Economic Commission for Europe**Inland Transport Committee****World Forum for Harmonization of Vehicle Regulations****Working Party on Passive Safety****Sixty-fourth session**

UN Regulation No. 129 (Enhanced Child Restraint Systems)**Proposal for the 04 series of amendments to UN
Regulation No. 129****Submitted by the expert from the European Association of Automotive
Suppliers***

The text reproduced below was prepared by the expert from the European Association of Automotive Suppliers (CLEPA) to include booster cushion category into the scope of UN Regulation No. 129. The modifications to the current text of the UN Regulation are marked in bold for new or strikethrough for deleted characters.

Figure 1
Sitting height check measurement device

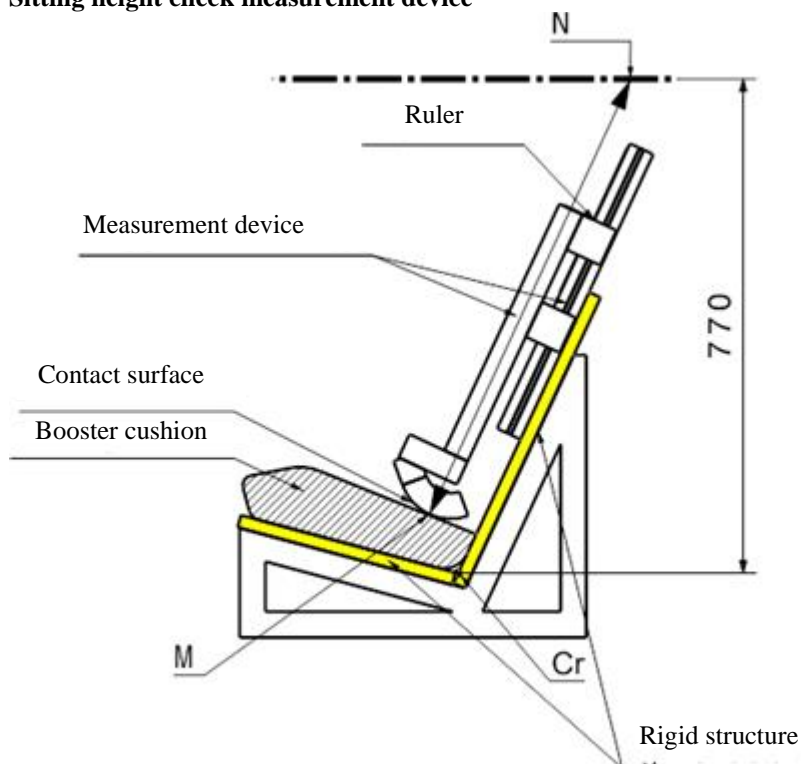
Booster cushions shall ensure that the top of the child's head is at or above a horizontal plane at 770 mm vertically from Cr when seated on the test bench described in Annex 6.

The procedure to check if a booster cushion fulfils this requirement is outlined as follows (See figure 1 below):

- (a) A rigid mock-up of the test bench, as defined in Annex 25, is used for this check. The mock-up shall have the same geometry as the R129 test bench with enough rigidity. For the rest of the text the mock-up is called simulated test bench.
- (b) A rigid structure is attached to the simulated test bench and holds a sliding part. A horizontal plane that is located at a vertical distance of 770 mm from Cr is defined.
- (c) The booster cushion shall be placed on the simulated test bench with its centreline aligned with the centreline of the test bench and the rear

Figure 2
Ruler of measurement device:

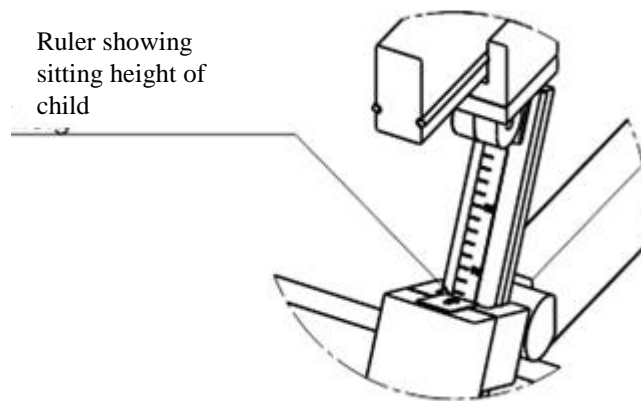
- (f) The measured distance between the two points M and N represents the sitting height of a child who will use the cushion represented in Figure 1. The corresponding value is displayed by a ruler that is provided with the device as shown in Figure 1.
- (g) Using the data in Table 3, the sitting height is utilized to determine the corresponding minimum stature of the child that can be accommodated by the booster cushion. Example: A sitting height of 70,2 cm shall correspond to a child minimum stature of 125 cm; a sitting height of 81,1 cm shall correspond to 150 cm.

In case the value obtained for the sitting height is between two integer values always round up to the next integer value (e.g. Measured sitting height = 72,9 cm ► resulting stature = 132.25 cm ► Smallest stature allowed = 133cm)

042439 Regulation No. 129/04

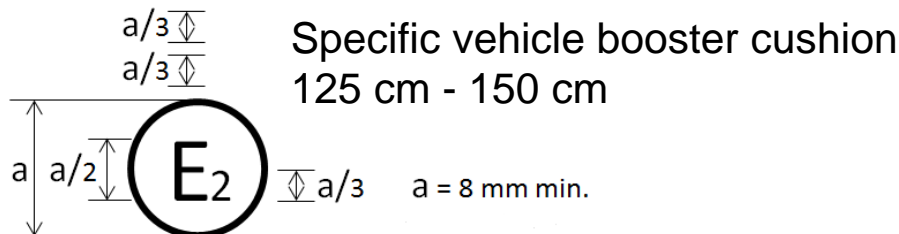
The Enhanced Child Restraint System bearing the above approval mark can be fitted in any i-Size seating position and used for the 125 cm - 150 cm size range; it is approved in France (E 2) under the number 042439. The approval number indicates that the approval was granted in accordance with the requirements of the Regulation concerning the approval of Enhanced Child Restraint Systems used on-board of motor vehicles as amended by the series of amendments. In addition, the name of the regulation is to be identified on the approval mark followed by the series of amendment according to which the approval has been granted.

The Enhanced Child Restraint System bearing the above approval mark is a device not capable of being fitted in every vehicle but capable of being used for the 125 cm - 150 cm size range; it is approved in France (E 2) under the number 042450. The approval number indicates that the approval was granted in accordance with the requirements of the Regulation concerning the approval of specific vehicle booster cushion Enhanced Child Restraint Systems used on-board of motor vehicles as amended by the 04 series of amendments. In addition the name of the Regulation needs to be identified on the approval mark followed by the series of amendment according to which the approval has been granted.

Figure 2A

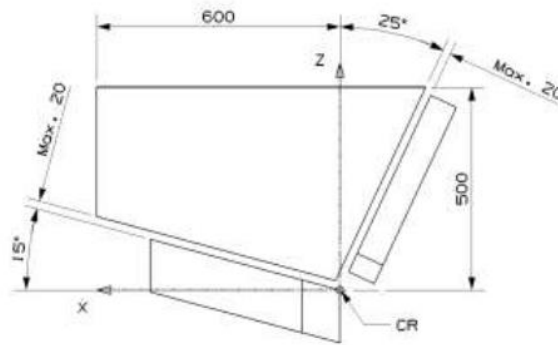
Door panel geometry for testing integral ECRS with ISOFIX – side view (tolerance general: ± 2 mm and ± 1 degree)

This door panel shall be used when the Integral ECRS under test is installed with ISOFIX.

Figure 2B

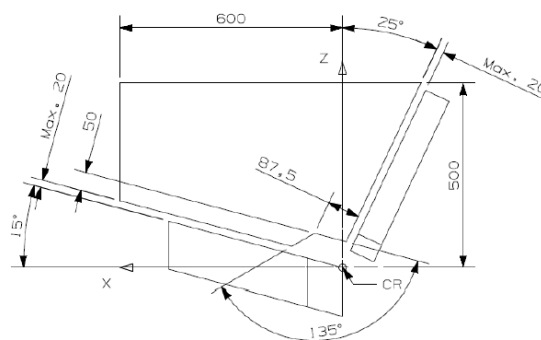
Door panel geometry for testing non-integral ECRS – side view (tolerance general: ± 2 mm and ± 1 degree)

This door panel shall be used when the ECRS under test is installed with the adult seat belt.

Tests to extend the type-approval of Integral ISOFIX ECRS may also use this door, provided it was used for the original type-approval.

Measurement device for booster cushion height check

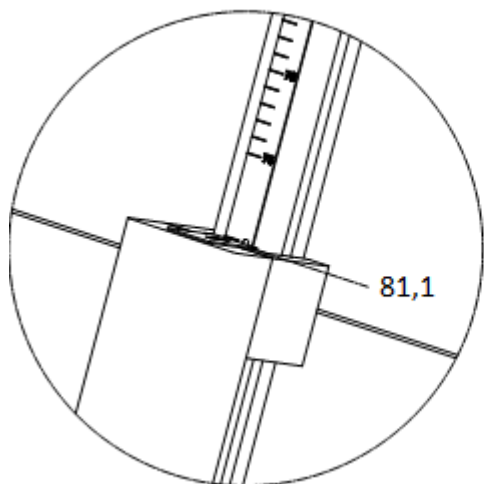
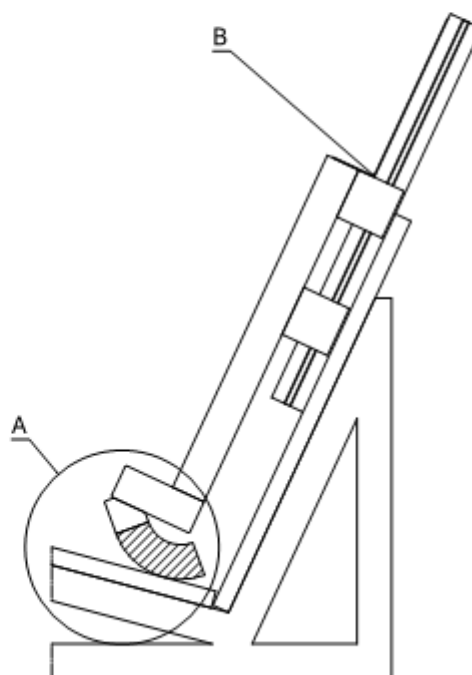
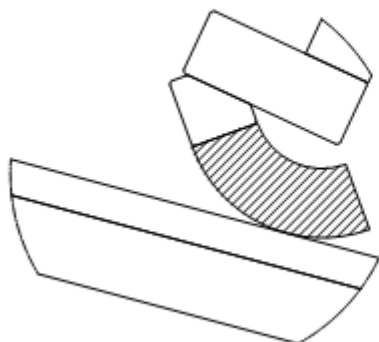
The calibration of the ruler is based on an idealized measurement in Computer-Aided design (CAD) using the frame of the measurement device on the rigid test bench simulating R129 test bench and a digital Q10 dummy. The dummy is raised so that its head is aligned with the horizontal bar at 770 mm and its back is in contact with the backrest of the test bench. In this position the distance from the dummy's bottom to the seat cushion of the test bench is measured. This distance is added to the sitting height

of the digital Q10 and the result is the calibration value. In our case the value is 81,1 cm.

To calibrate the ruler of the measurement device its structure has to contact the supporting surface (Detail A). In this configuration the scale has to show the calibration value – 81,1 cm (Detail B).

Figure 1

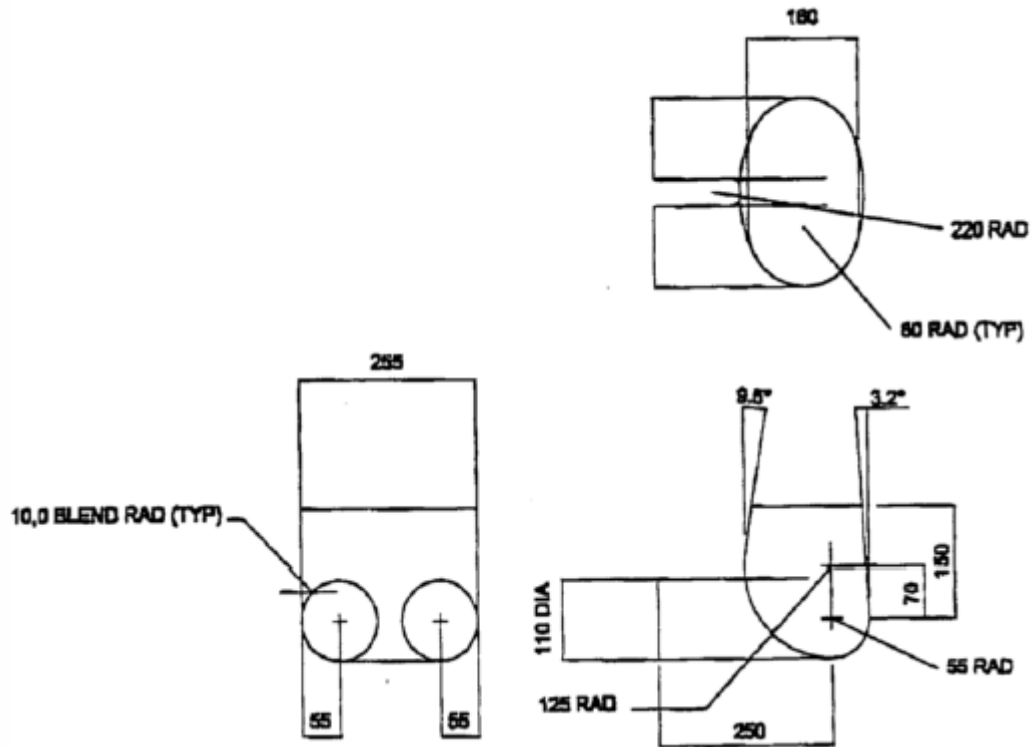
Manikin block (based on truncated P10)

Material: Expanded polystyrene (EPS) (40 to 45 g/l)

Booster pull test using manikin block

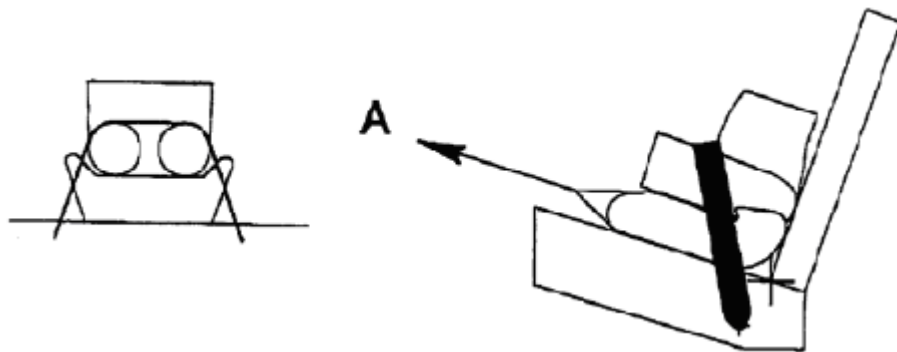
Place a cotton cloth on the seating surface of the test bench. Position the booster cushion on the test bench, position the lower torso body block as described in Annex 26, Figure 1, on the seating surface, fit and apply the 3-point adult safety-belt and tension as prescribed in paragraph 7.1.3.5.2.2. With a piece of 25 mm width webbing or similar tied round the booster, apply a load of 250 ± 5 N in the direction of arrow A, see Annex 26, Figure 2, in line with the seating surface of the test bench.

It should not be allowed that the booster cushion is completely pulled out under the lower torso body block."
